DART SERVICE INSTRUCTION

TO AMEND INSTALLATION INSTRUCTIONS D205-634 REV. D/E AND
INSTRUCTIONS FOR CONTINUED AIRWORTHINESS ICA-D205-634 REV. 1/2

REF. CANADIAN STC: SH96-88

FOR D205-634-011 SKID TUBES @ CHANGE 006 AND SUBSEQUENT AND D205-634-015 AT CHANGE 005 AND SUBSEQUENT,
THE D2968-041 TOW RING HAS BEEN REPLACED WITH D3407-045 TOW RING ASSEMBLY.
AMEND THE PARTS LIST IN SECTION 5.0 OF INSTALLATION INSTRUCTIONS D205-634 REV. D/E AND SECTION 32.9 OF
THE INSTRUCTIONS FOR CONTINUED AIRWORTHINESS ICA-D205-634 REV. 1/2 AS FOLLOWS:

INSTALL TOW RING ASSEMBLY AS SHOWN BELOW (REFER TO FIGURE 3, DETAIL C OF D205-634 REV. D/E AND FIGURE 32-3, DETAIL C OF ICA-D205-634 REV. 1/2). AMEND SECTION 3.1.3 OF OF D205-634 REV. D/E AND SECTION 32.5 OF ICA-D205-634 REV. 1/2 ACCORDINGLY.

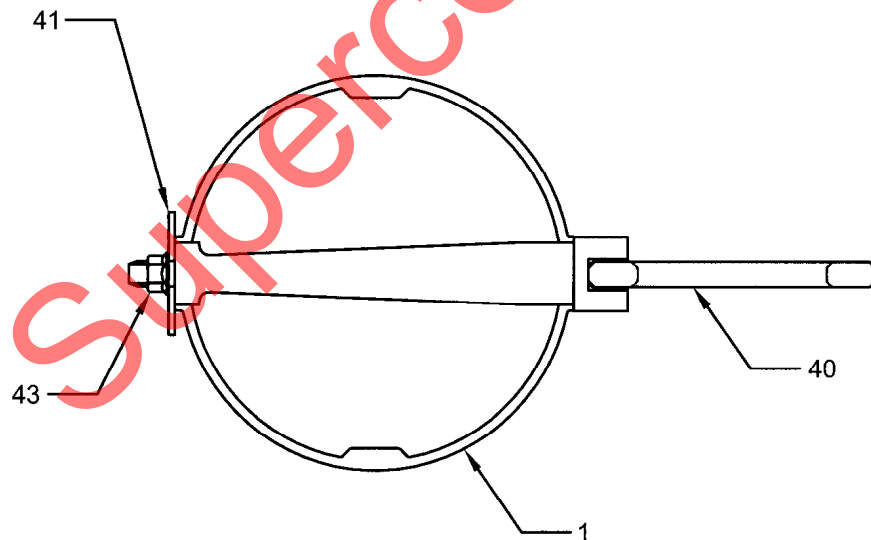
IS:

WAS:
